REMARKS

Applicants respectfully request reconsideration of the above-captioned application. The Office Action of June 19, 2002 includes an objection to the disclosure suggesting that conventional subtitles be used. While it does not appear that the Office has the authority to impose the use of such subtitles, Applicants have no difficulty in inserting them to overcome the concerns expressed in the Office Action. Withdrawal of this objection is respectfully requested.

Fig. 2

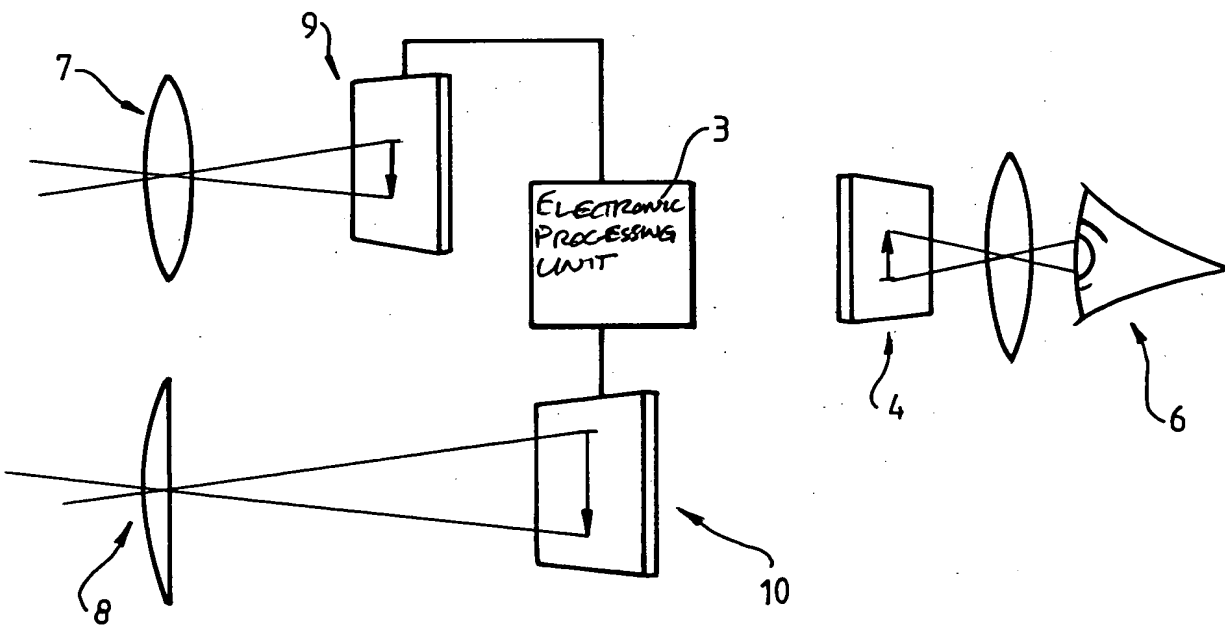
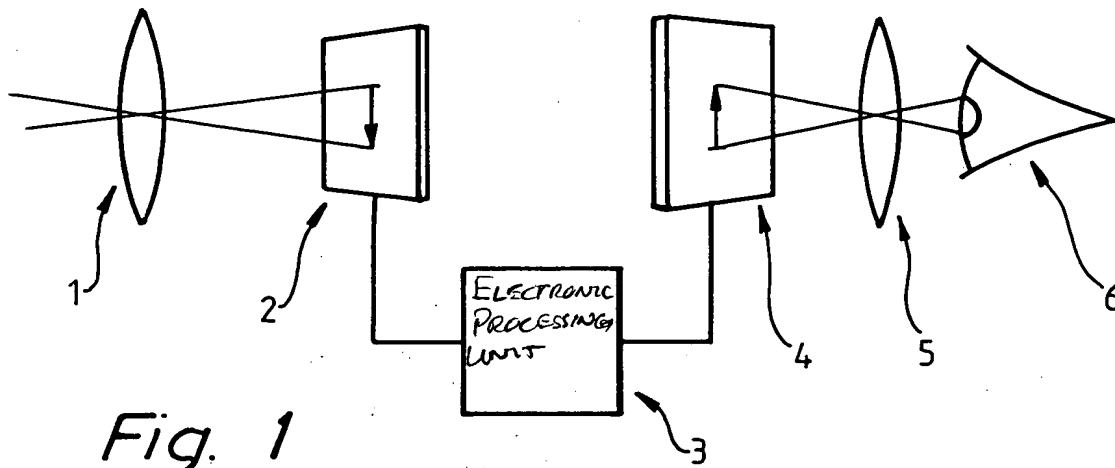
The Office Action also includes an objection to the drawings suggesting that the symbolically illustrated structure bare legends. Concurrently filed herewith is a Request for Approval of Drawing Changes in which element 3 of Figures 1 and 2 is to be labeled with the legend "Electronic Processing Unit". Approval of these drawing changes and withdrawal of this objection are respectfully requested.
